Product Change Notice (PCN)

Subject: Change of Waffle Pack Label Display

Publication Date: 7/6/2021

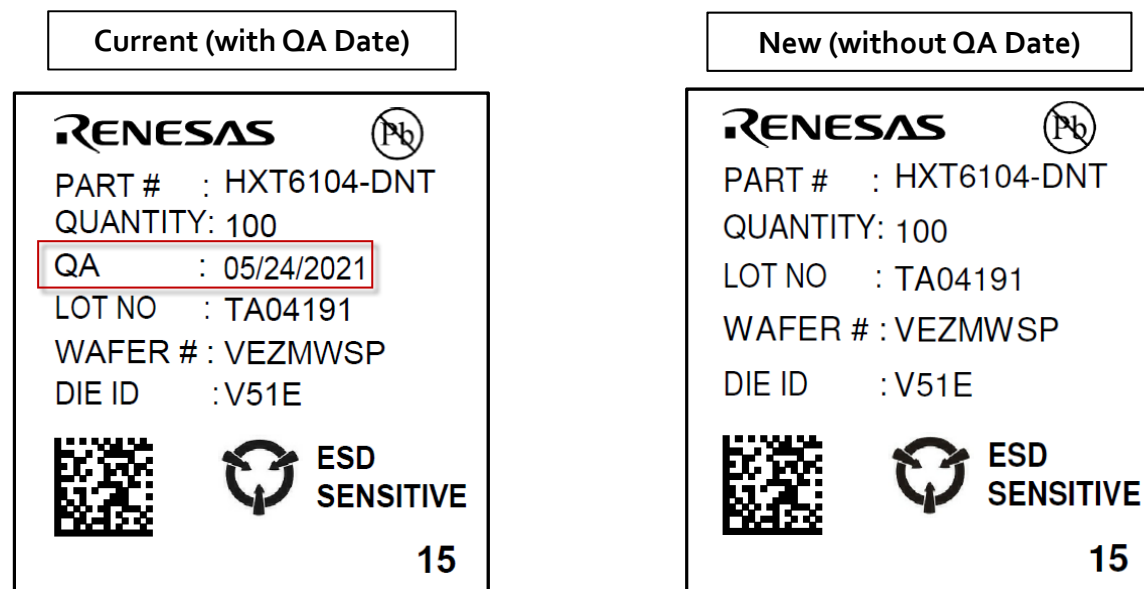
Renesas is updating the waffle pack label by removing the QA date from the label display. Others remain unchanged. Refer sample label changes as depicted below.
